Access Compliance Report

Public Rights-of-Way

Intersection ID: 18011	Main Street: PARK_RD	Cross Street: HEATHER_LN	Location: NW
ADA ID: 07D8F8F581C6	Ramp Type: Perp	Initial Pass/Fail: Fail	Overall Compliance: No
Severity Score: 46.25			
Codes/Mitigation Info/Possible Solution		Field Measurements/Component Compliance

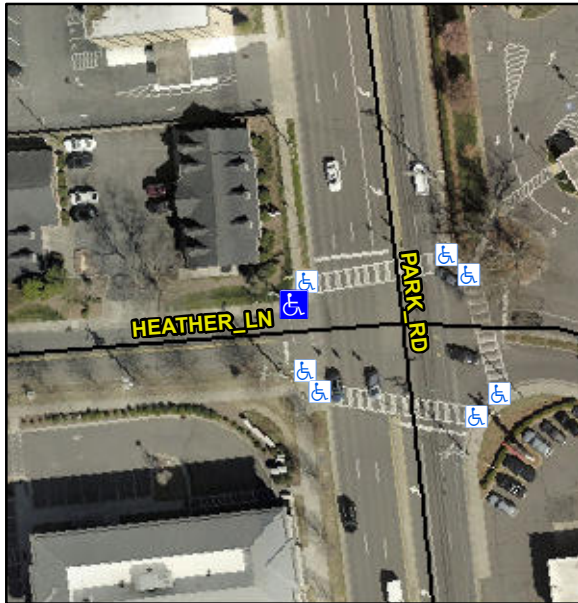
Not Found, R304.5.1, R304.2.2, R304.5.3

Compliance	Description	Data	Compliance	Description	Data
N/A	Ramp Length (in)	77.0	No	Ramp Slope (%)	10.3
No	Ramp Width (in)	46.0	No	Ramp XSlope (%)	9.6
N/A	Flare Type LT	N/A	N/A	Flare Type RT	N/A
N/A	Flare Slope LT (%)	N/A	N/A	Flare Slope RT (%)	N/A
N/A	Flare Traversable LT?	N/A	N/A	Flare Traversable RT?	N/A
N/A	Landing Length (in)	N/A	N/A	DWS Provided?	N/A
N/A	Landing Width (in)	N/A	N/A	DWS Contrast?	N/A
N/A	Landing Slope (%)	N/A	N/A	DWS Length (in)	N/A
N/A	Landing X Slope (%)	N/A	N/A	DWS Full Width?	N/A
N/A	Landing Curb? (Y/N)	N/A	N/A	DWS Offset (in)	N/A
N/A	Shared Landing?	N/A			
N/A	Gutter Ponding?	N/A	N/A	Gutter Slope (%)	N/A
N/A	Gutter Lip Ht (in)	N/A	N/A	Gutter X Slope (%)	N/A
N/A	Painted X Walk1?	No	N/A	Painted X Walk2?	N/A
	X Walk 1 Direction	To S		X Walk 2 Direction	N/A
N/A	X Walk 1 Width (in)	N/A	N/A	X Walk 2 Width (in)	N/A
	X Walk 1 Slope (%)	2.9		X Walk 2 Slope (%)	N/A
	X Walk 1 X Slope (%)	6.2		X Walk 2 X Slope (%)	N/A

Remove & Replace Entire Ramp.
